Determination 2019/052

Regarding the compliance of a pool barrier to the extent required by section 162C of the Building Act for an indoor pool at 83 Roland Road, Auckland

Summary

Figure 1: Plan indicating type and location of pool room doors⁵

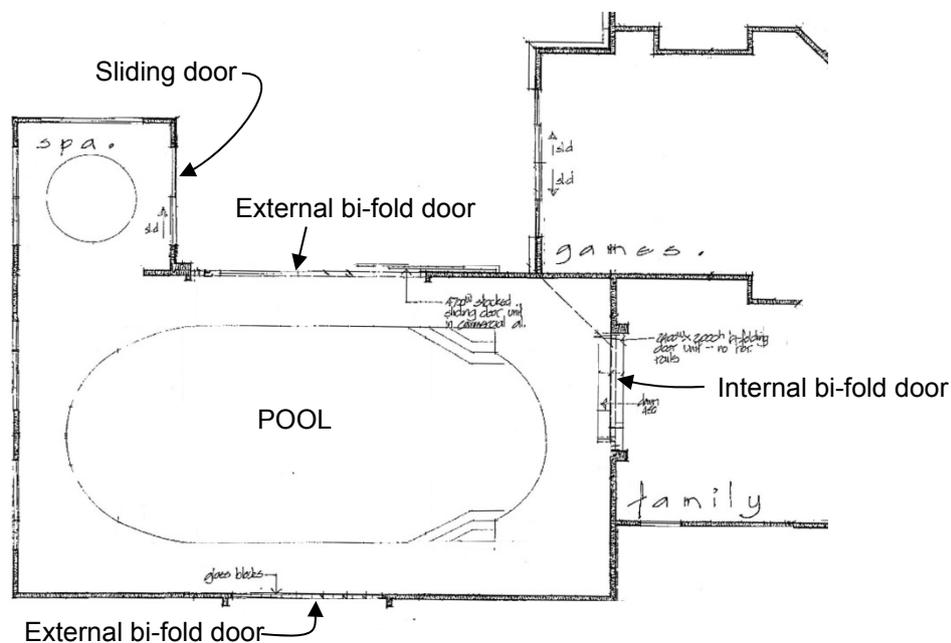
- 2.2 The walls, doors and windows of the pool room form a physical barrier surrounding the immediate pool area⁶. From the authority's 31 January 2019 pool inspection checklist⁷, details provided by the applicant and the other information supplied to me, it appears there are four doors in the pool room as follows (images of these are provided in Figure 2):

- one set of bi-fold doors at the end of the pool room ("the internal bi-fold door") providing access to/from the rest of the house (also refer to sketch in Figure 3). This door has four leaves and is approximately 2300mm wide. According to the applicant, it can be opened from the living area/family room by releasing

- two sets of bi-fold doors located on opposite sides of the pool room (“the external bi-fold doors”) which open up fully to the outside. These doors have latches top and bottom on the inside of the door, with the top latches set about 1700mm above floor level. From the photographs supplied, they have six leaves that can be folded outward and then slid back.
- a sliding door next to the spa. This door has a single latch and lock at approximately 900mm above floor level on the inside face of the door. The door opens to a maximum of 1000mm wide.

Figure 3: The internal bi-fold door⁹ (sketch by applicant, not to scale)

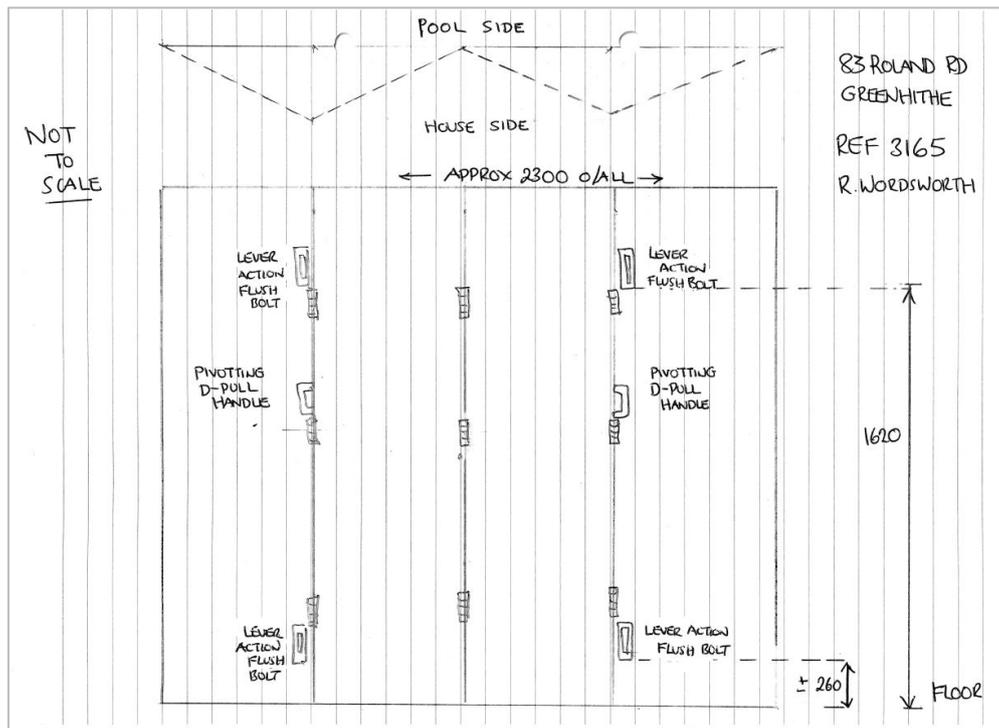
- 4.1.4 On 2 August 2019 I received a sketch of the internal bi-fold door (seen in Figure 3) and a letter from the applicant dated 30 July 2019. In this letter the applicant described the door’s action and bolts saying that, as the upper bolt levers were at least 1625 mm above floor level, these were considered out of reach of a small child “and obviously exceed the minimum guideline^[16] height of 1500[mm]”. The applicant also considered the dead weight of the door leaves plus the surface friction of the door sliders made opening the door too difficult for a small child. “Likewise, the stiff operation of the lock levers themselves is considered beyond the strength capacity of said child.”

- 5.4.8 Regarding whether the doors open inwards, this is not relevant to the sliding door and the applicant has confirmed that both of the external bi-fold doors open outward. However, based on the photograph taken by the authority of the internal bi-fold door (refer to Figure 2(a)), it appears that the leaves of this door open inwards towards the immediate pool area, i.e. the force used in opening the doors includes pushing towards the pool rather than pulling away from the pool. I note also the completed checklist for the authority's pool inspection on 31 January 2019 recorded that not all doors opened away from the pool (refer to paragraph 3.3). In my opinion the internal bi-fold door does not meet all the criteria in Clause 8 of the Schedule.

- 5.4.20 Now turning to the three bi-fold doors, these cannot be opened unless the upper bolts are released. The levers for these bolts are above the 1500mm height typically accepted as not easily accessible by young children. Further, when one leaf is latched the adjacent leaf is unable to be opened. I also accept the applicant’s view that the weight of the internal bi-fold doors would make them difficult for young children to move and therefore to access the immediate pool area.

- 5.4.21 Accordingly, taking into account the mechanics of opening the bi-fold doors, which includes operating upper bolt levers which are not easily accessible by young children, and the size and weight of these doors, I do not consider these doors would be “readily opened by children” from outside the pool area.
- 5.4.22 However, the doors must also meet the requirements of Clause F9.3.4(a)(i) or (ii) to comply. The doors to this pool area are not self-closing and do not have an audible alarm.
- 5.4.23 Further, I am not aware of any other features of these doors that would serve to demonstrate compliance with Clause F9.3.4(a) as an alternative means of compliance.
- 5.4.24 Therefore, I consider that the barrier does not currently comply with section 162C by way of the current Clause F9.
